Proposal to amend the draft 01 series of amendments to Regulation No. 127 (Document ECE/TRANS/WP.29/2014/38)

"Figure 11
Example of marking of HIC1000 zone and HIC1700 zone

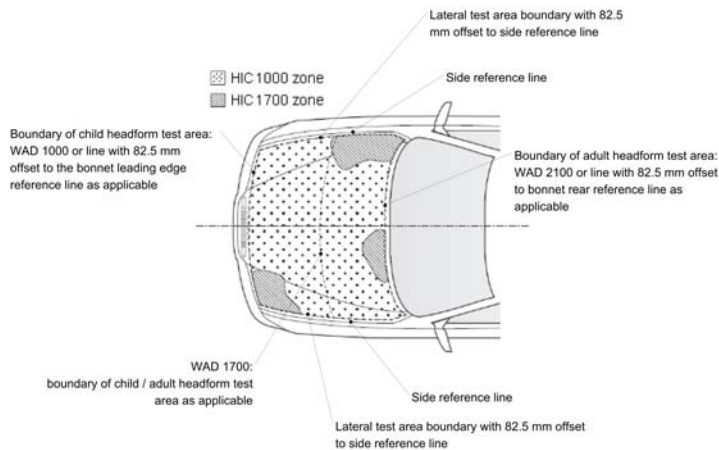
Annex 5, Figure 11 Example of marking of HIC 1000 zone and HIC 1700 zone, replace the Republic of Korea proposal as follow;
